Memorandum to the City of Markham Committee of Adjustment

July 28, 2021

File: A/091/21
Address: 156 Church Street – Markham, ON
Applicant: Mary Ratnarajah
Agent: Gregory Design Group (Shane Gregory)
Hearing Date: August 11, 2021

SITE PLAN
 SCALE - 1:300
 LOT INFORMATION & DATA

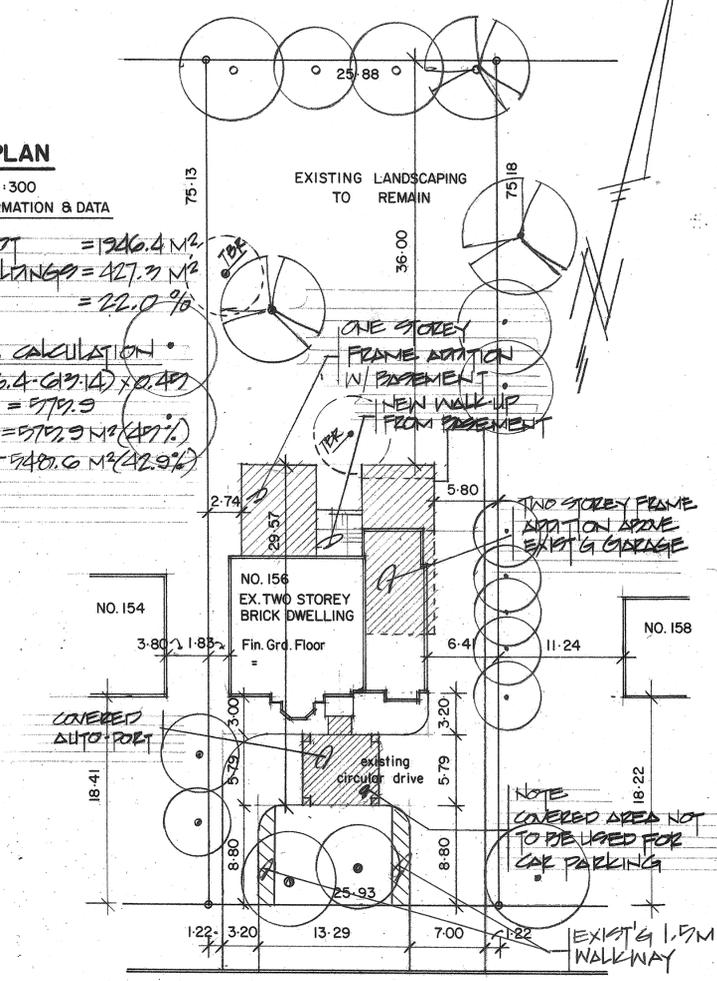
The property is subject to the Parking By-law, and the proposed development does not comply with the Parking By-law requirement with respect to the maximum width of a second driveway. The applicant indicates that the covered and unenclosed “autoport” structure is not to be used for car parking (see Site Plan, “Appendix “B”). The applicant should be made aware that an additional variance would be required to permit a carport in the front yard, in any event where the carport is to be used for parking purposes.

The existing driveway complies with the above criteria, except where the second driveway has a width of 5.79 m (19.0 ft) which exceeds the maximum width by 2.09 m (6.86 ft). The applicant is therefore requesting a variance to recognize the existing site condition (see Site Plan, Appendix "B").

3. That the second driveway with a requested width of up to 5.79 m (19.0 ft) shall only apply to the section of the driveway traversing east-west and situated a minimum of 8.0 m (26.25 ft) north of the front lot line as it is shown in the batch stamped plan attached as Appendix "B" to this Staff Report, and that no additional hard landscaping be permitted in the front yard.

APPENDIX "C"
AREA CONTEXT: LOT DEPTHS

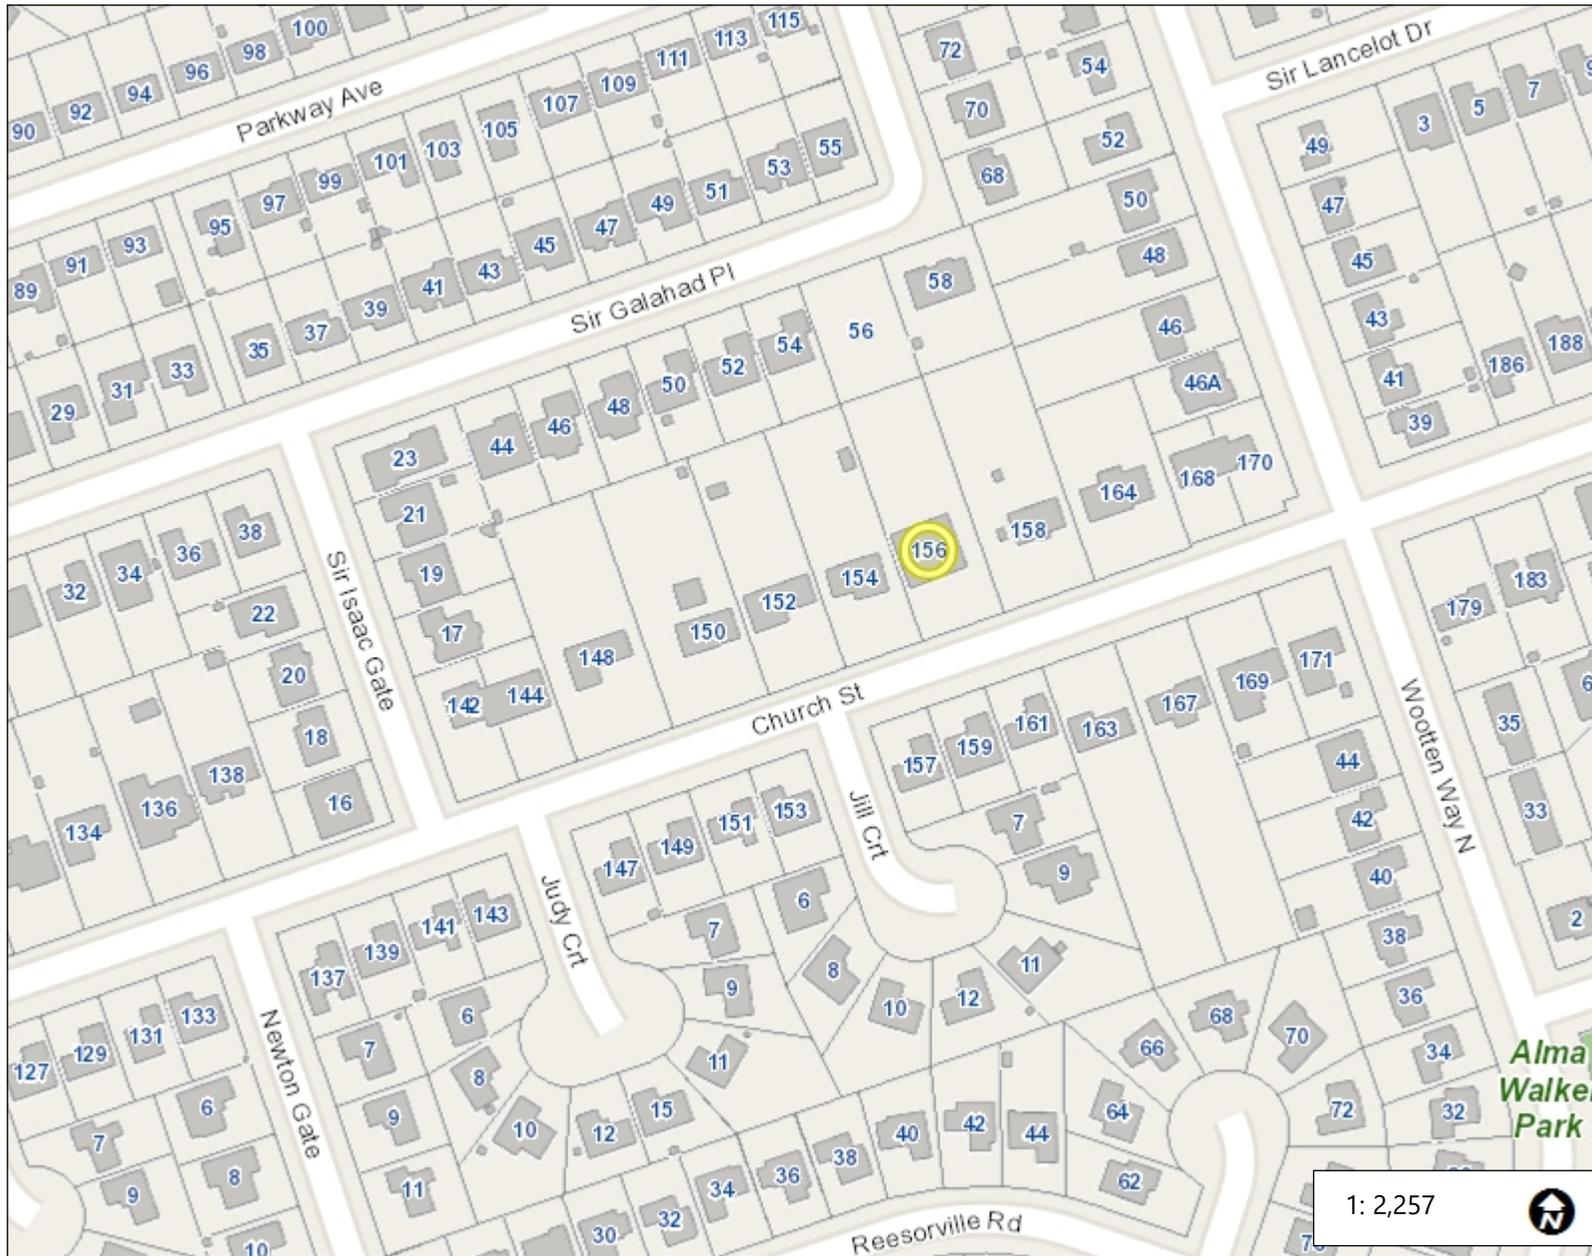
Approximate residential lot depths along the street between Elm Street, and 9th Line range from 33.53 m (110.0 ft) to 102.11 m (335.0 ft) according to City records. The subject property has a lot depth of 75.15 m (246.56 ft) which is greater than many lots on the street (see Appendix "C"). While staff are of the opinion that the building depth is appropriate for the lot, the requested variance represents a considerable departure from the By-law requirement. In considering, the depth and size of the property, the relationship of the proposed development with neighbouring properties, and the massing elements proposed, staff consider the requested variance to be supportable under the four tests of the *Planning Act*.
